## Revised Agenda

**Wednesday, December 15, 2021**

As part of the City's commitment to safety during the COVID-19 pandemic, this meeting of the **Committee of Adjustment** will be held electronically.

# **COMMENTS**

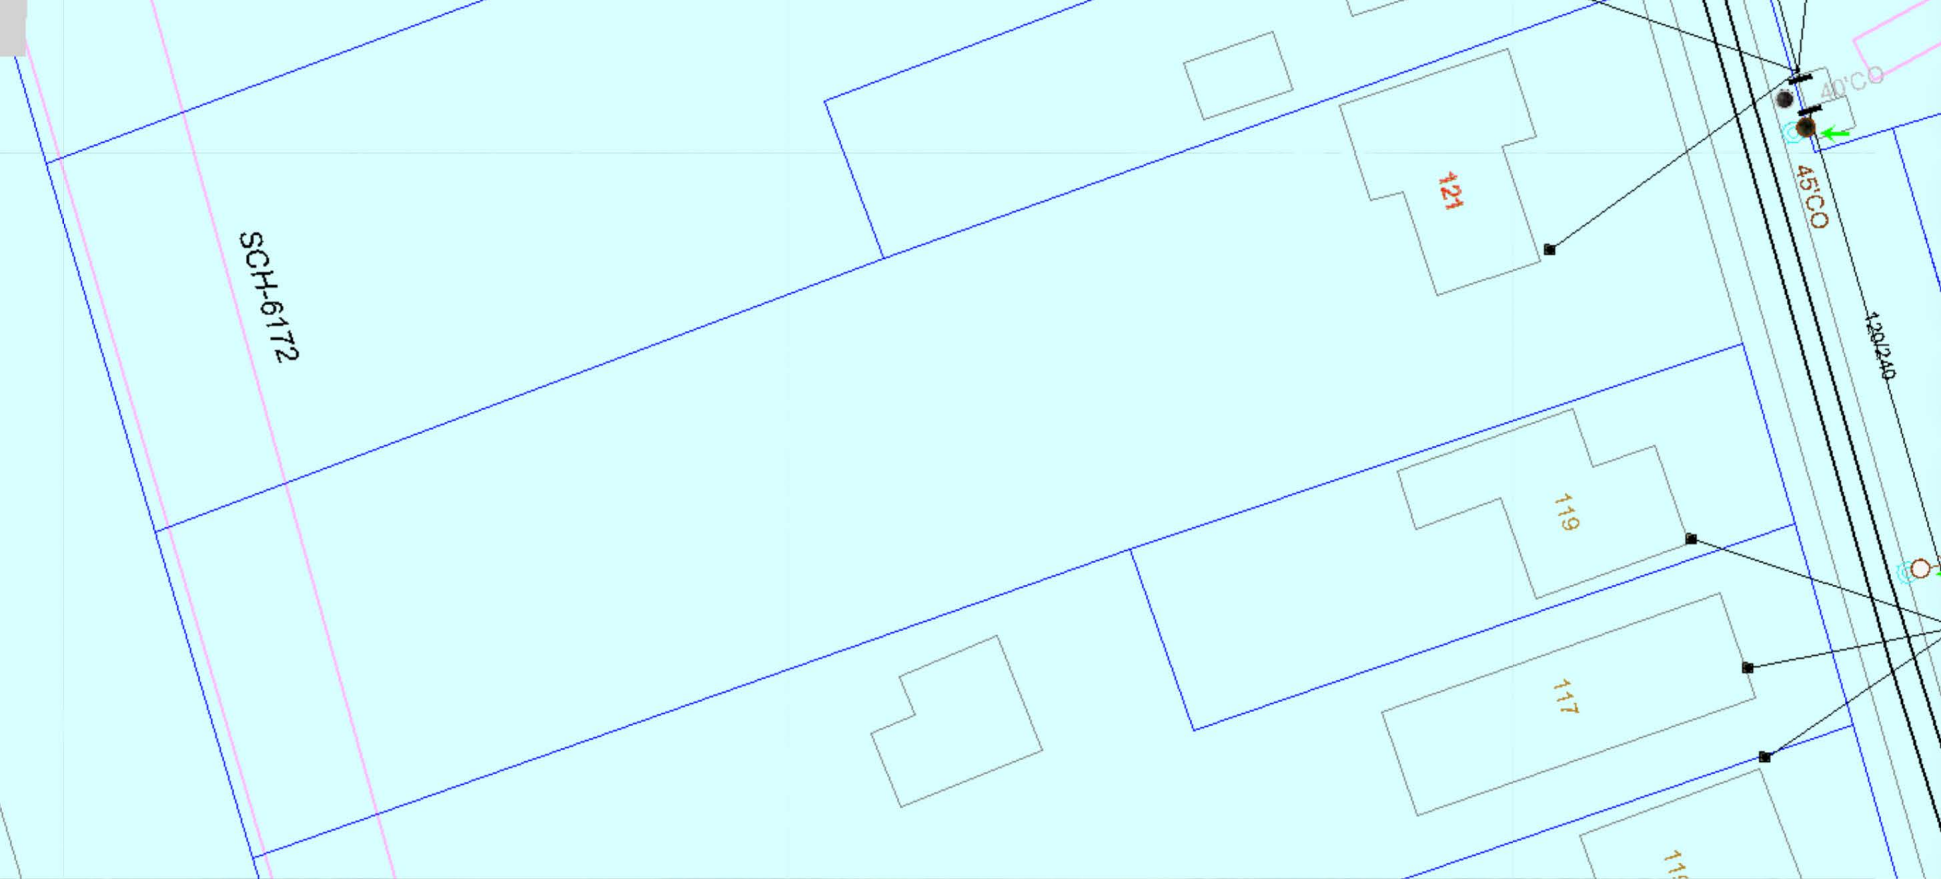
- Existing Alectra Utilities easement (SCH6172) at rear of proposed severed part 1 to remain clear of any proposed future development.

- Do not excavate within two metres of hydro poles and anchors.
- Excavation within one metre of underground hydro plant is not permitted unless approval is granted by an Alectra Utilities representative and is present to provide direct supervision. Cost associated with this task shall be at the owner's expense.

- Alectra Utilities must be contacted if the removal, isolation or relocation of existing plant is required, all cost associated with this work will be at the owners expense.

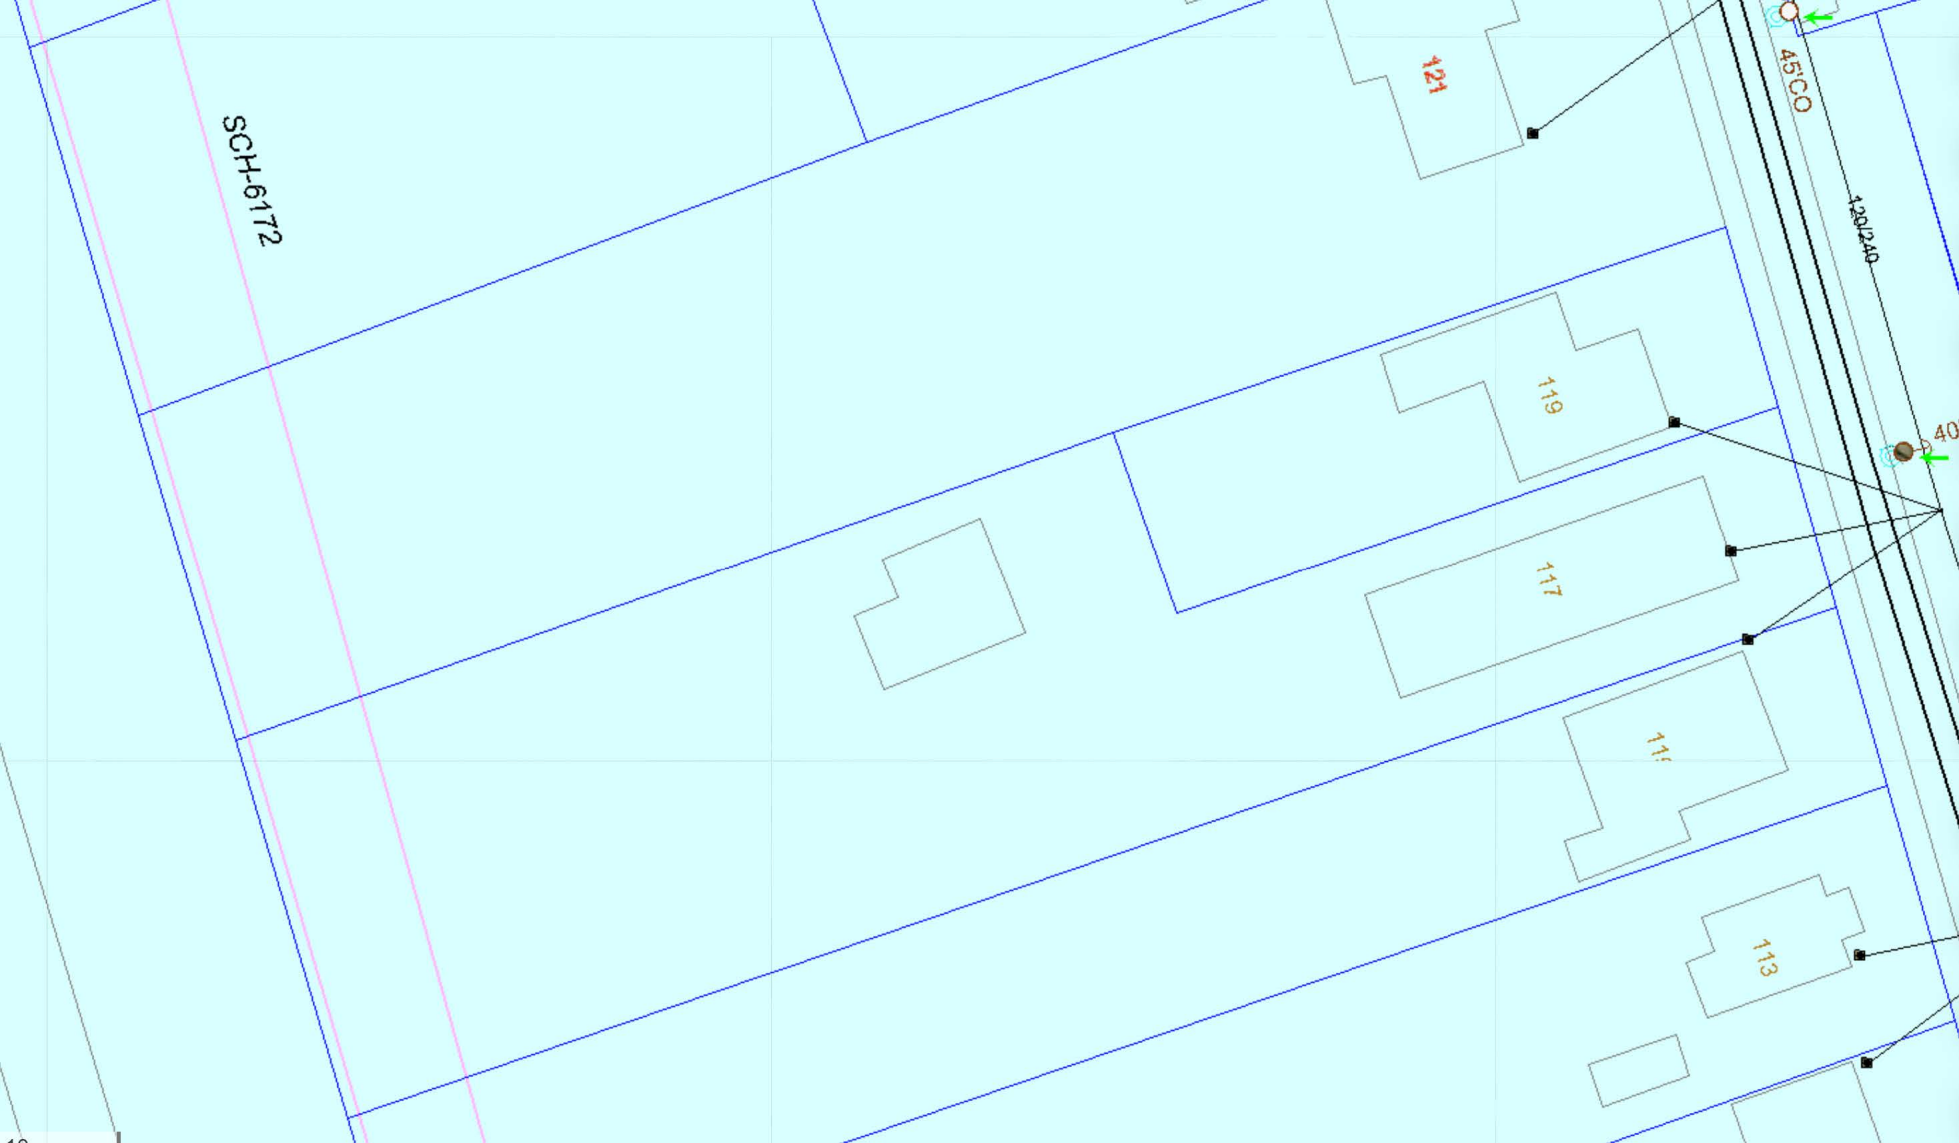
- Existing Alectra Utilities easement (SCH6172) at rear of proposed severed part 1 to remain clear of any proposed future development.

- Do not excavate within two metres of hydro poles and anchors.
- Excavation within one metre of underground hydro plant is not permitted unless approval is granted by an Alectra Utilities representative and is present to provide direct supervision. Cost associated with this task shall be at the owner's expense.

- Alectra Utilities must be contacted if the removal, isolation or relocation of existing plant is required, all cost associated with this work will be at the owners expense.

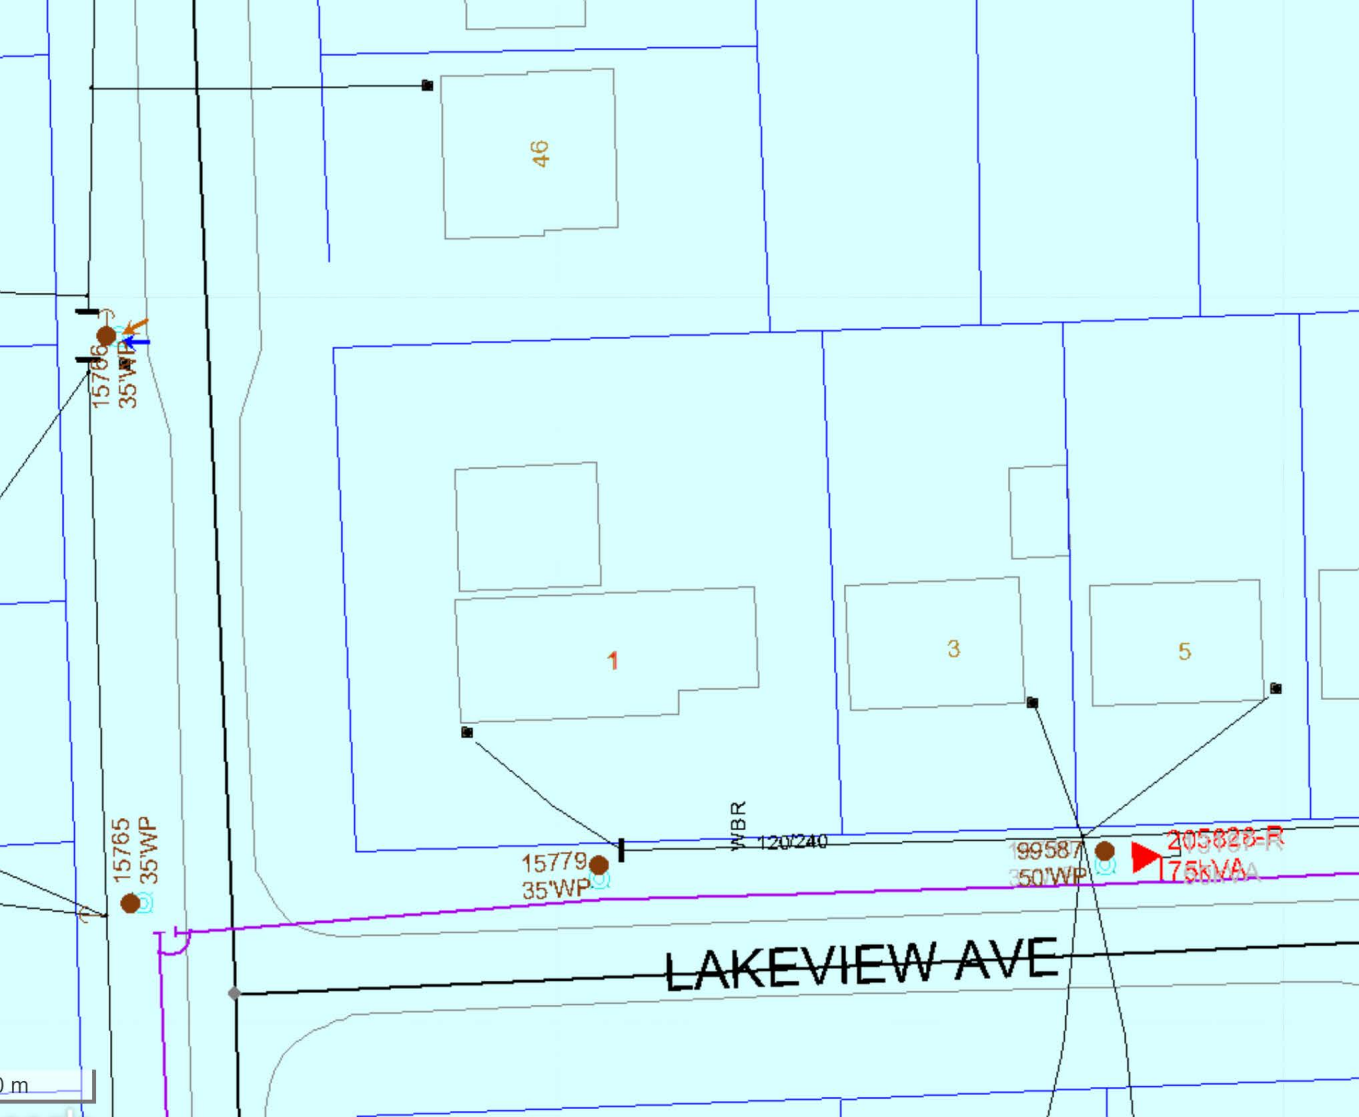
- Do not excavate within two metres of hydro poles and anchors.

- Excavation within one metre of underground hydro plant is not permitted unless approval is granted by an Alectra Utilities representative and is present to provide direct supervision. Cost associated with this task shall be at the owner's expense.

- Alectra Utilities must be contacted if the removal, isolation or relocation of existing plant is required, all cost associated with this work will be at the owners expense.
